Subject: Revision 10a of the Inservice Testing Program for Pumps and
Revision 13a of the Inservice Testing Program for Valves
Byron Nuclear Power Station, Units 1 and 2
Facility Operating Licenses NPF-37 and NPF-66
NRC Docket Nos. 50-454 and 50-455

Revision 10a of the Byron IST Pump Program is provided in Enclosure 1. Attachment A provides a summary of all of the changes associated with this revision. The two major changes are discussed below.

Revision 13a of the Byron IST Valve Program is provided in Enclosure 2. Attachment B provides a summary of all of the changes associated with this revision. The major changes are discussed below.

FIGURE 2

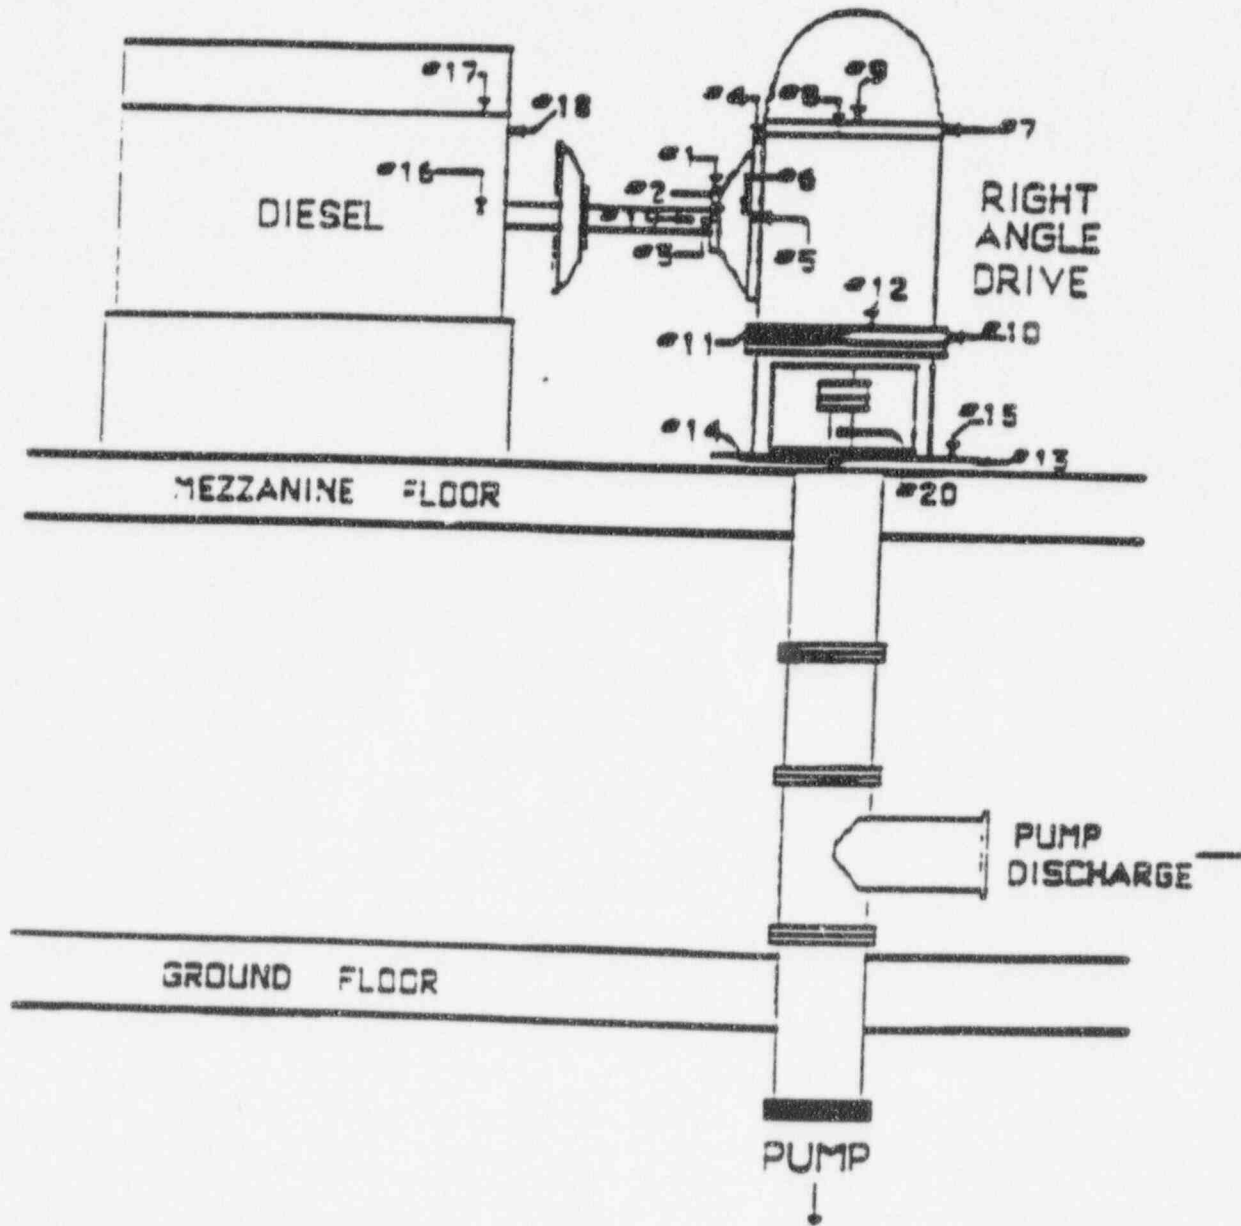
The Essential Service Water Makeup Pumps OSX02PA & B are of a very unique design (see Fig. 1 and Fig. 2). The pump is attached to a horizontal diesel driver via a right angle gear drive, and the gear drive is located approximately 39 feet above the pump. This configuration assures pump operability during the design basis flooding of the Rock River.

The Essential Service Water Makeup Pumps OSX02PA & B are classified as centrifugal pumps. ANSI/ASME OMa-1988 Part 6 Paragraph 4.6.4 (a) requires that for centrifugal pumps, vibration measurements are to be taken in two directions on each accessible pump bearing housing and in the axial direction on each accessible pump thrust bearing housing. The OM Code does not require vibration monitoring of the gear drive. For the Essential Service Water Makeup Pumps, however, the pump thrust bearings are physically located within the gearbox which houses the gear drive. This pump configuration is not addressed by OM Part 6. With this unique configuration, the only means of collecting vibration readings for the pump thrust bearing is to physically take the vibration measurements on the gear box itself. The limitations of taking the vibration readings at this location is that the resultant vibration readings are not solely attributable to the pump thrust bearing. The vibration readings obtained are the result of other factors such as the vibration induced by the gear drive itself.

When recording vibration results based on a frequency response range to 2000 Hz., which has been the customary practice at Byron for these pumps, the gear drive significantly contributes to the vibration which is measured at the gearbox location. The vibration induced by the gear drive is largely due to the gears meshing. Taking into account the pump running speed and the number of gear teeth, Byron has calculated the gear mesh frequency and hence a vibration frequency attributable to the gear drive. This frequency was calculated to be 1080 Hz. By performing spectral analysis of the vibration data obtained at the gearbox locations, engineering personnel were able to identify the vibration which was attributable to the gear drive, as there was an easily identifiable peak within this 1080 Hz frequency range. This particular peak, associated with the gear mesh frequency, exceeded the acceptance criteria of Table 3a of OM Part 6. The OM Part 6 Table 3a

acceptance criteria applies to pump bearings and pump thrust bearings, and not to gear drives which induce vibration due to the gears meshing. Additionally, Paragraph 4.6.1.6 of OM Part 6 states that the frequency response range of the vibration measuring transducers and their readout system shall be to at least 1000 Hz. The 1080 Hz gear mesh frequency goes beyond what is required for the frequency response range of the vibration measuring transducers and their readout system. As a result, for the gearbox locations on these pumps, Byron will apply the OM Part 6 Table 3a acceptance limits in the frequency range of one third minimum pump shaft rotational speed up to and including 1000 Hz, and will not apply the OM Part 6 acceptance limits to the gear drive frequencies above 1000 Hz. By applying a cutoff at 1000 Hz, the resulting peak reading is more applicable to the vibration from the pump thrust bearing. The 1000 Hz cutoff meets the requirements of OM Part 6 for frequency response range of the vibration measuring transducers and their readout system. Additionally, vibration measurements will continue to be taken at the lowest accessible bushing on the pump shaft. These vibration readings will be subject to the OM Part 6 Table 3a acceptance criteria.

Both the A and B pumps have experienced vibration at the gearbox location in the vicinity of 0.4 - 0.45 in/sec since installation, at which time they were verified by the vendor to be operating properly. They have continued to display such vibration levels throughout their service life. In August of 1992, the gearbox for pump OSX02PA was replaced. The replacement was performed due to repair work which was performed on the pump and was not attributable to a gearbox problem. It was felt that this was an opportunity to discover if a rebuilt gearbox would reduce the vibration levels. Replacement with a rebuilt gearbox did not significantly reduce vibration levels at the gearbox location. Additionally, an inspection of the original gearbox revealed that it was in an acceptable condition. Also, in 1995 the OSX02PA gearbox was opened and visually inspected. It should be noted that the OSX02PA pump has experienced slightly higher vibration levels at the gearbox location than the OSX02PB pump. The gearbox of the OSX02PA pump was found to be in excellent condition. ComEd's conclusions are that the vibration levels recorded at the gearbox locations do not have a detrimental affect on the gearbox or the pump, and that this vibration level is normal for such a pump configuration. Although the OM Code vibration limits will not be applied to the vibration levels attributed to the gear mesh frequencies, Byron will continue to monitor these vibration levels, and take action as appropriate.
